FACTORS		PROFILES								
		1	2	3	4	5	6	7	8	9
LANDSCAPE POSITION	.1940									
SLOPE (%)	.1940									
HORIZON 1 DEPTH		036	08	036						
Texture Group	.1941(A)(1)	W/S	W/S	W/S						
Consistence	.1941									
Structure	.1941(A)(2)									
Mineralogy	.1941(A)(3)									
HORIZON 2 DEPTH			8-24							
Texture Group	.1941(A)(1)		SC							
Consistence	.1941									
Structure	.1941(A)(2)									
Mineralogy	.1941(A)(3)									
HORIZON 3 DEPTH										
Texture Group	.1941(A)(1)									
Consistence	.1941									
Structure	.1941(A)(2)									
Mineralogy	.1941(A)(3)									
HORIZON 4 DEPTH										
Texture Group	.1941(A)(1)									
Consistence	.1941									
Structure	.1941(A)(2)									
Mineralogy	.1941(A)(3)									
SOIL WETNESS	.1942	—	—	—						
RESTRICTIVE HORIZON	.1944									
SAPROLITE	.1943/1956									
CLASSIFICATION	.1948	S	PS							
LONG TERM ACCEPTANCE RATE	.1955	.8	.4	.8

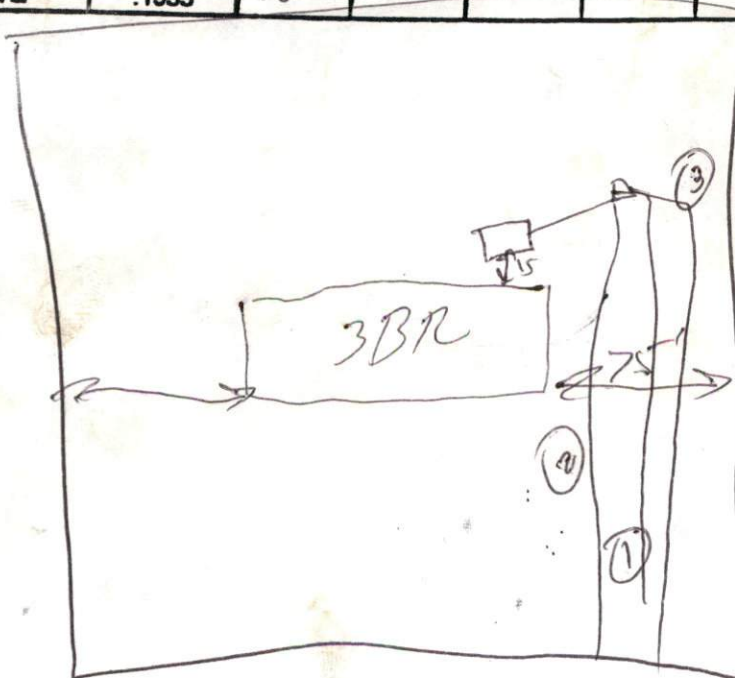
#2-rock at 24"

need borings for pits
10 Aug 2000

Basement - will it have plumbing
